Product/Process Change Notice (PCN)

PCN #:   ConUSB2_20161219

Product Affected: 62910416121

Old Design	New Design

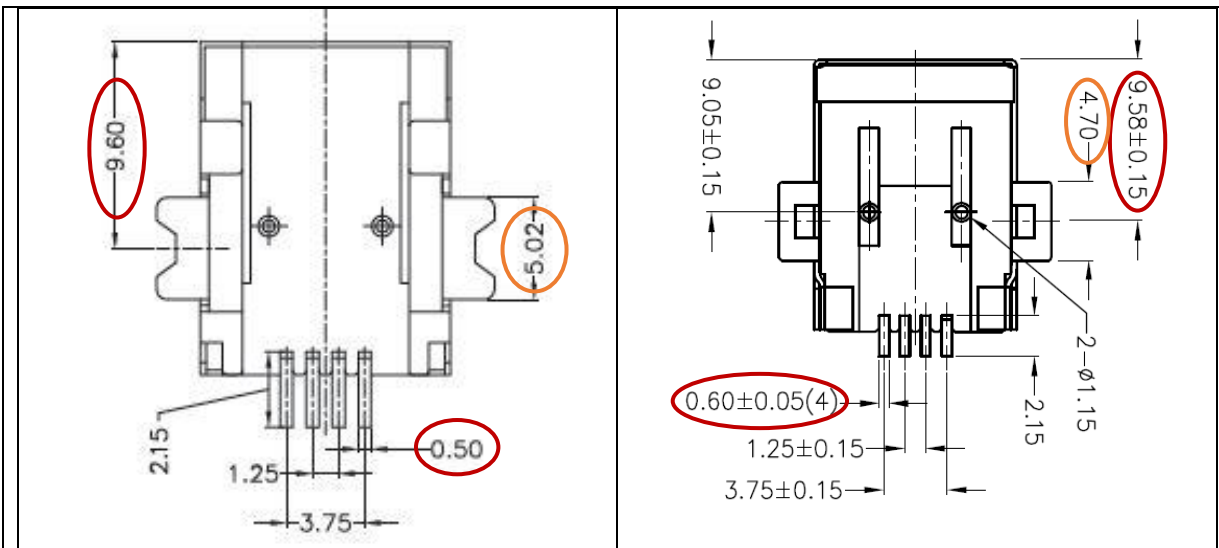
For improved processability on this product, Würth Elektronik adjusted some shielding dimensions, still compatible with original layout recommendations.
Due to packaging optimization and transportation safety improvement, quantity per reel has been increased from 150 pieces to 200 pcs.
Products after product change with effective date of 2nd of January 2017 are available with lot number 243xxxxxxxxxxxx.

1.   The design changes are summarized below and marked in red:
